Work Order ID 74505

Item Name: Lug Assembly

DRAWING NO. D3394	TITLE LUG	REV. B	DART AEROSPACE LTD ENGINEERING ORDER		D.E.O. NO. D3394-B-1	SHEET NO. SHEET 1 OF 1	SCALE NTS
DRAWN AJS	CHECKED	MFG. APPR.	APPROVED	DE APPR.			
DATE 09.11.04	DATE 09.11.04	DATE 09.11.04	DATE 09/11/04	DATE 09/11/04

DRAWING NO. D3394	TITLE LUG	REV. B	DART AEROSPACE USA, INC ENGINEERING ORDER		D.E.O. NO. D3394-B-2	SHEET NO. SHEET 1 OF 1	SCALE NTS
DRAWN JP	CHECKED SC	MFG. APPR. M	APPROVED MP		DE APPR. H		
DATE 11.05.02	DATE 11.05.09	DATE 11.05.09	DATE 11.05.09		DATE 11.05.09

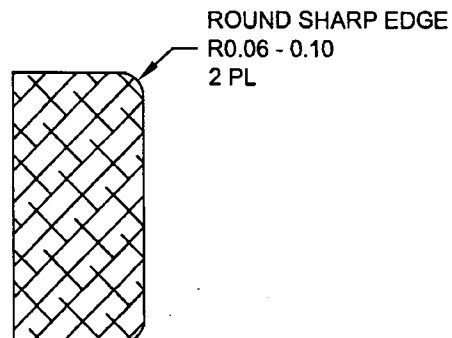
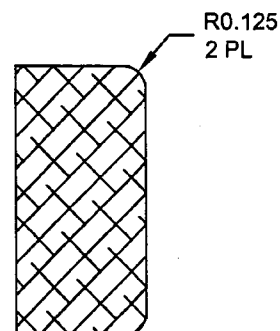
SHEET 4 ZONE A,1 MODIFY SECTION A-A AS SHOWN:

IS:

WAS:

REASON: DRAFTING ERROR

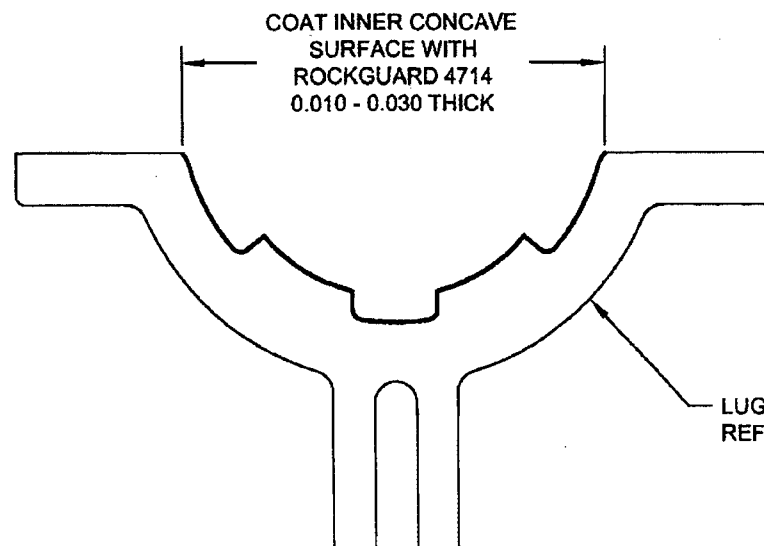
ADD D3394-xRG OPTION

D3394-xRG MOUNTING LUGS ARE IDENTICAL TO D3394-x MOUNTING LUGS, HOWEVER AFTER FINISH, COAT INNER CONCAVE SURFACE WITH "PLUS ONE ROCKGUARD 4714" AS SHOWN BELOW.

D3394-1RG LUG (SHOWN)
D3394-3RG/-5RG LUGS (SIMILAR)
D3394-041RG/-043RG/-045RG LUG ASSEMBLIES (SIMILAR)
